CITY OF ALBUQUERQUE

Re: TI @ 1430 Broadway SE
1430 Broadway Blvd SE
Traffic Circulation Layout
Engineer's/Architect's Stamp 1/31/20 (L14D062)

A TENANT IMPROVEMENT AT 1430 BROADWAY BLVD. SE
 ALBUQUERQUE, NEW MEXICO

TCL

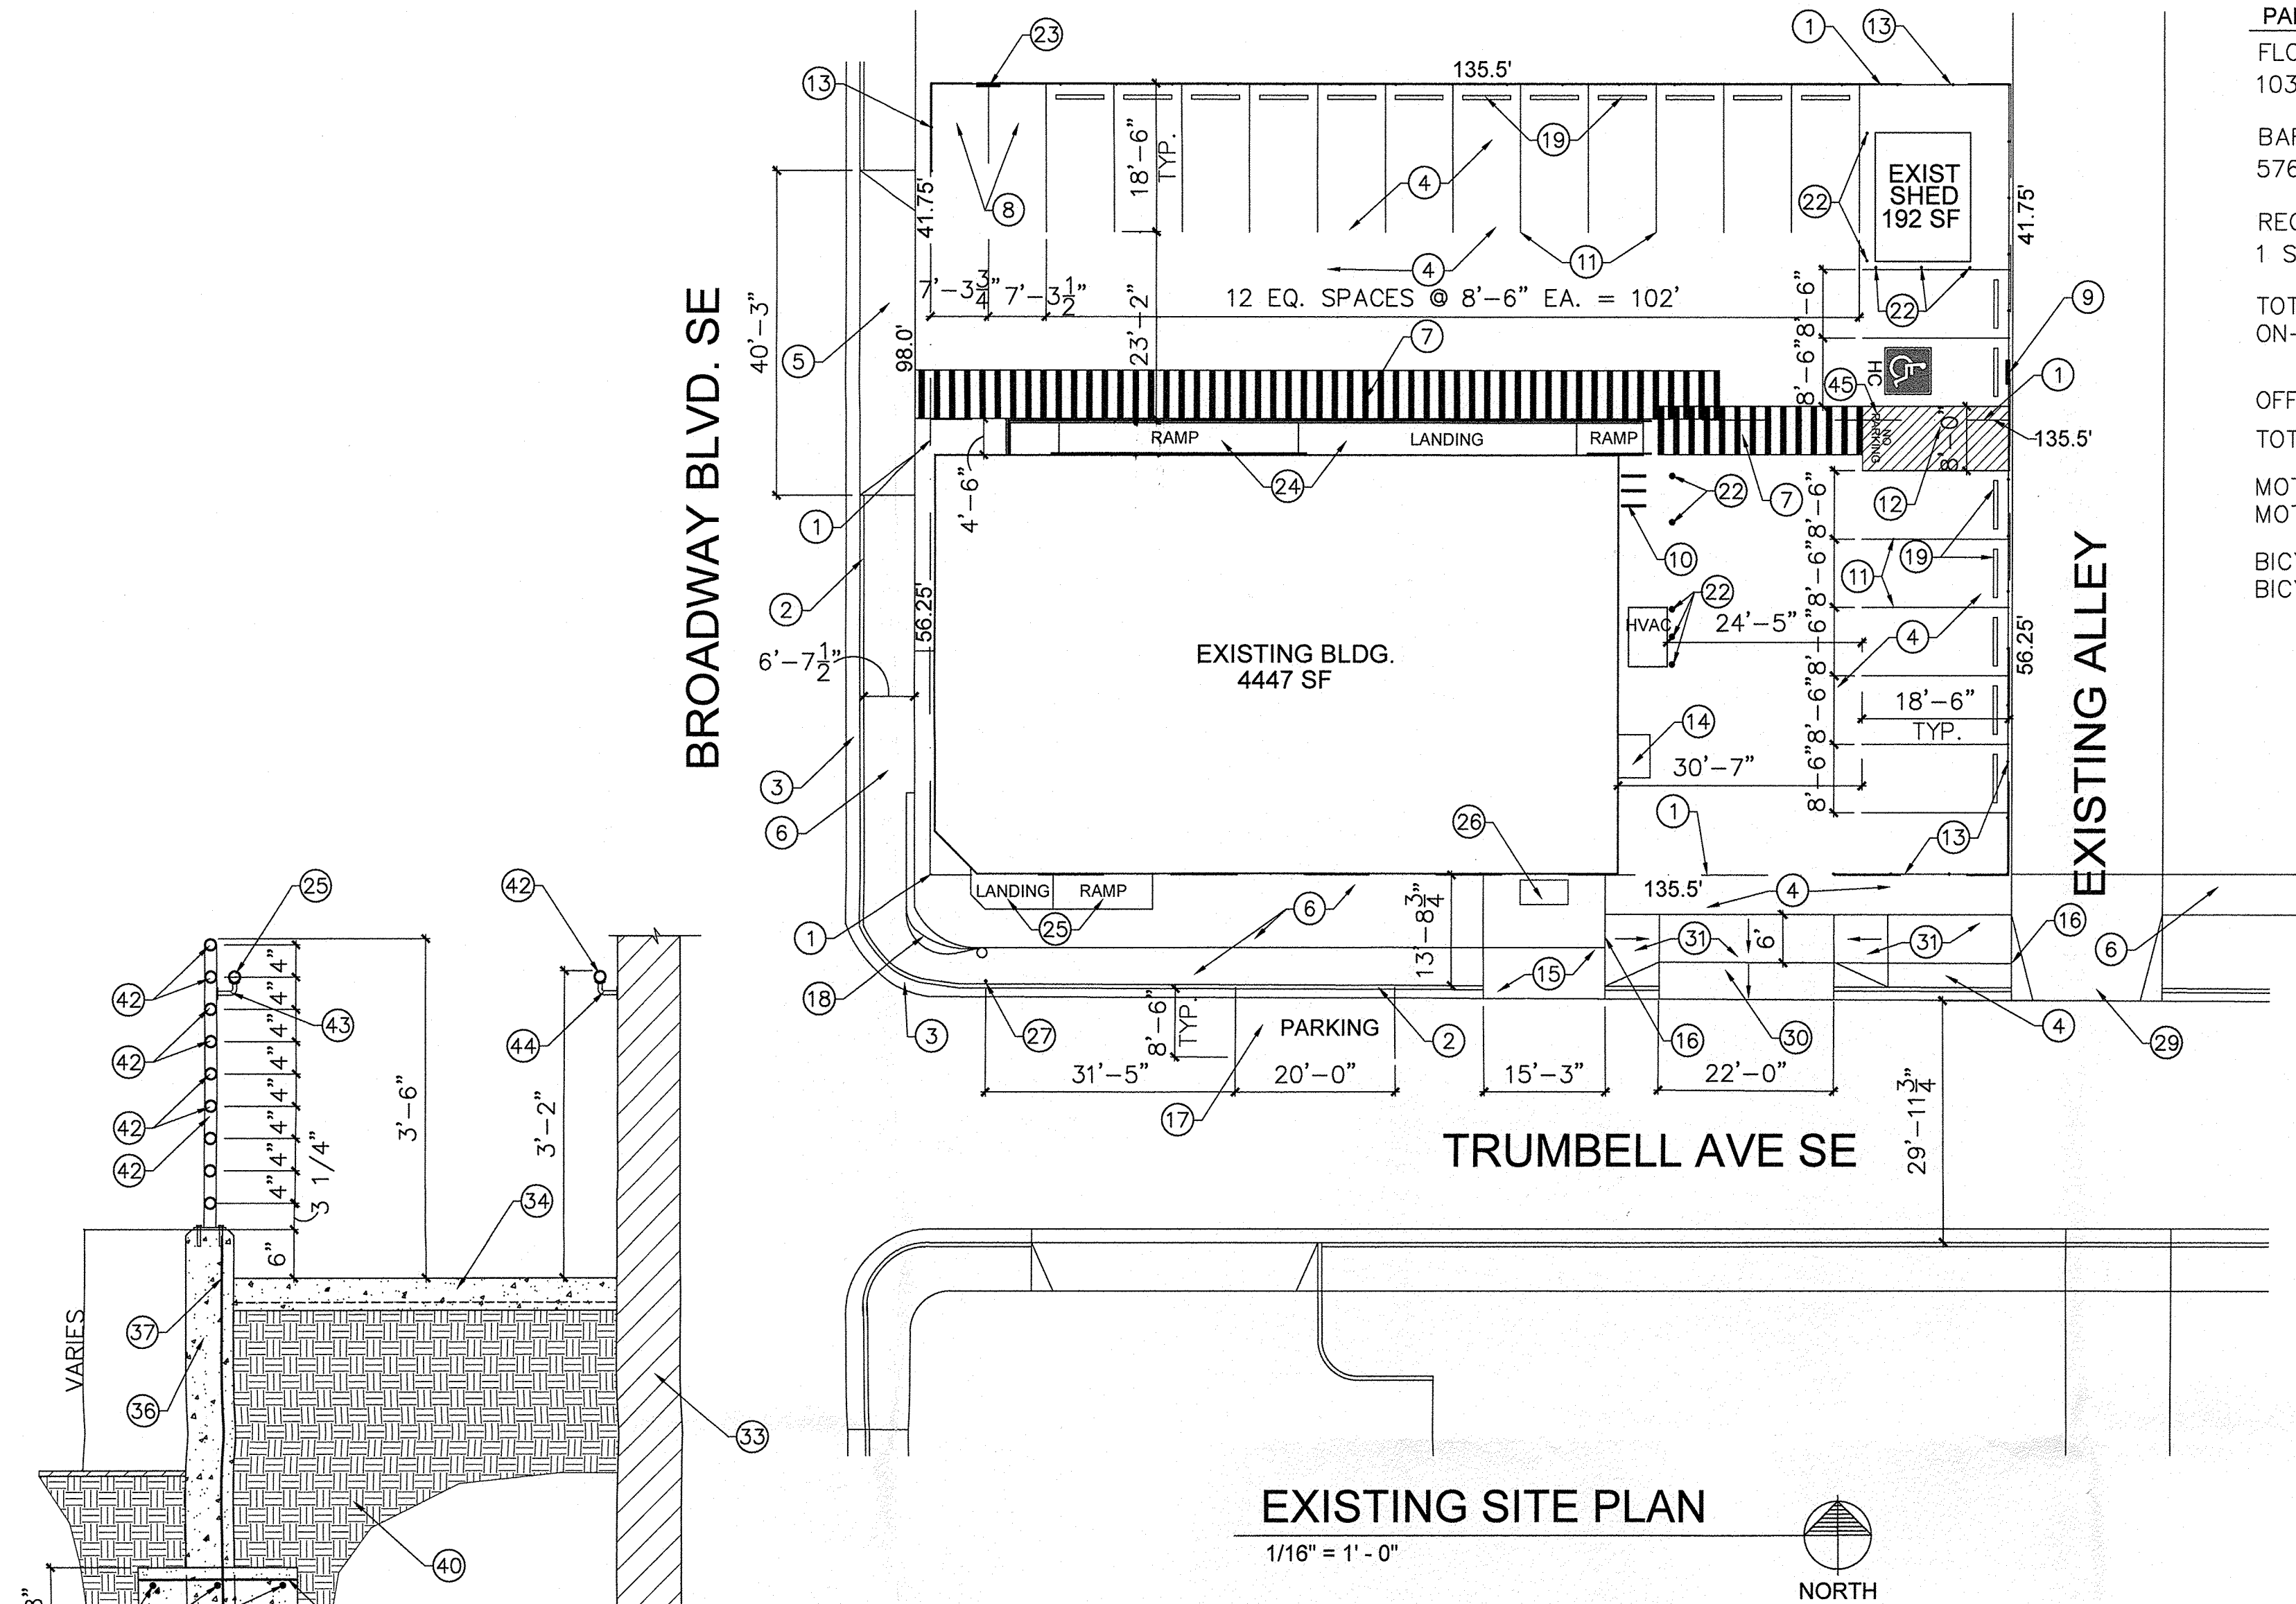
The TCL submittal received 1-31-2020 is approved for Building Permit with. A copy of the stamped and signed plan will be needed for each of the building permit plans. Please keep the original to be used for certification of the site for final C.O. for Transportation.

When the site construction is completed and an inspection for Certificate of Occupancy (C.O.) is requested, use the original City stamped approved TCL for certification. Redline any minor changes and adjustments that were made in the field. A NM registered architect or engineer must stamp, sign, and date the certification TCL along with indicating that the development was built in "substantial compliance" with the TCL. Submit this certification, the TCL, and a completed Drainage and Transportation Information Sheet to front counter personnel for log in and evaluation by Transportation.
